ADDENDUM 2

HARROW COUNCIL

PLANNING COMMITTEE

DATE: 21st November 2018

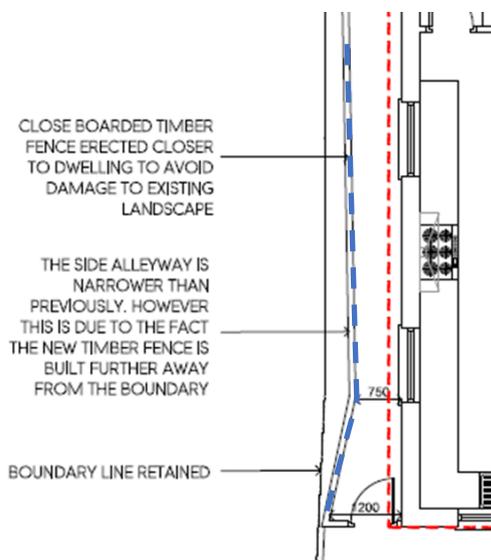
There would be a 0.75 metre gap for pedestrian access between the flank elevation of the two storey side extension and the shared boundary with No. 119.

Correction - Should read '*there would be a 1 metre gap*' as per approved plan P/1472/18

This element has not been built in accordance with the approved plans. The side wall has been set in from the boundary shared with number 119 by approximately 0.22m. In addition the fencing has been moved from the actual boundary and erected within number 121 to protect the greenery and this has resulted in the reduction in width of the pedestrian access.

The 'boundary line retained' is drawn incorrectly. The blue dashed line superimposed on the drawing below and white line on the aerial photo is the true boundary. The 'boundary line retained' as marked on the submitted drawing would cut through our downstairs toilet and side gate clearly displayed on the photo. We request a site visit to confirm the boundary error and correct (accurate) drawings submitted by 121 to enable 119 to retain the correct boundary line between properties before any decision is made.

'There would be a gap of 1.0m as per approved application P/3509/14'

Whilst that statement and correction is correct, it does not change the fact that the extension has been pushed inwards in order to protect the hedging and therefore reducing the passageway to 0.75m. The approved scheme did not take account of the hedging.

This boundary line is correct as per the location plan.
